Subject: Contract B-0290, "Laboratory Evaluation of DOE Radionuclide Solubility Data and Selected Retardation Parameters, Experimental Strategies, Laboratory Techniques and Procedures"

I have reviewed the August, 1984 Monthly Progress Report for the subject contract dated September 7, 1984. Based on my review, progress to date is satisfactory.

Figure 1

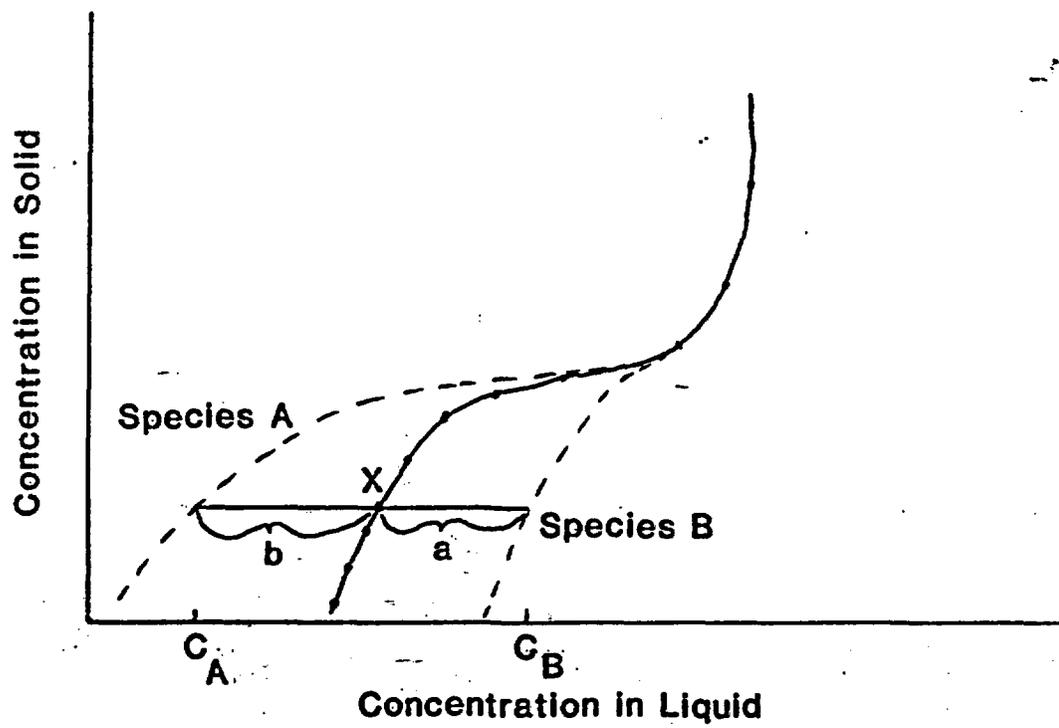
The statement has been made that when multiple species are present in solution "the sorption isotherm measured represents a weighted average of the sum of the curves for the individual species and will be conservative for more strongly adsorbed species and nonconservative for less strongly adsorbed species". Figure 1 is a sorption isotherm modified after Figure 4 of the Letter Report.

From the discussion, point X is the measured concentration (or bulk composition) of radionuclide in solution. The discussion and diagram imply that the "lever rule" can be used to describe concentrations of species in solution. Thus, $X = bC_B/(a+b) + aC_A/(a+b)$, where a is the quantity of solution containing A at concentration C_A and b is the quantity of solution containing B at concentration C_B . However, the lever rule is normally used to explain the relationship between quantities and compositions of two phases. Here, the lever rule is being applied to one phase, the liquid. Furthermore, in Figure 1, the chemical conditions (Eh, pH, ligands, etc.) necessary to produce the isotherm involving pure B in the liquid are different from those necessary to produce the isotherm involving pure A. These conditions are, in turn,

different from those in the sorption experiments involving both A and B. Thus, the three isotherms represent three separate sets of experiments and comparison to evaluate conservatism is invalid. (In addition, the apparent solubility limit could be different for the different set of conditions, e.g. U as a function of pH.)

Figure 2

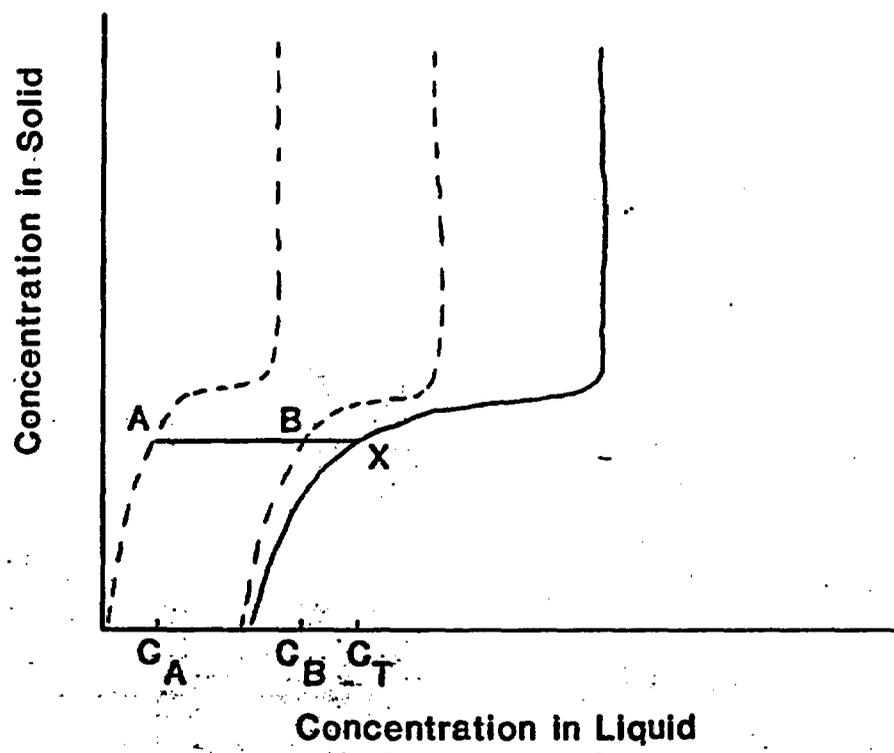
Figure 2, an idealized sorption isotherm, is produced from a set of batch sorption experiments in which all physicochemical parameters (T, P, X_j) are held constant and only the radionuclide concentration (X_1) is allowed to vary. For comparison of Figures 1 and 2, the measured isotherm (solid line) in Figure 2 can vary between the extreme isotherms (dashed lines) in Figure 1 in response to changes in the physicochemical conditions of the experiments. The total concentration (C_T) of radionuclide in solution is $C_A + C_B$. Under these conditions, C_T is always greater than or equal to C_A or C_B . Thus, when considering multiple speciation, batch experiments should yield conservative results for a given set of physicochemical conditions.
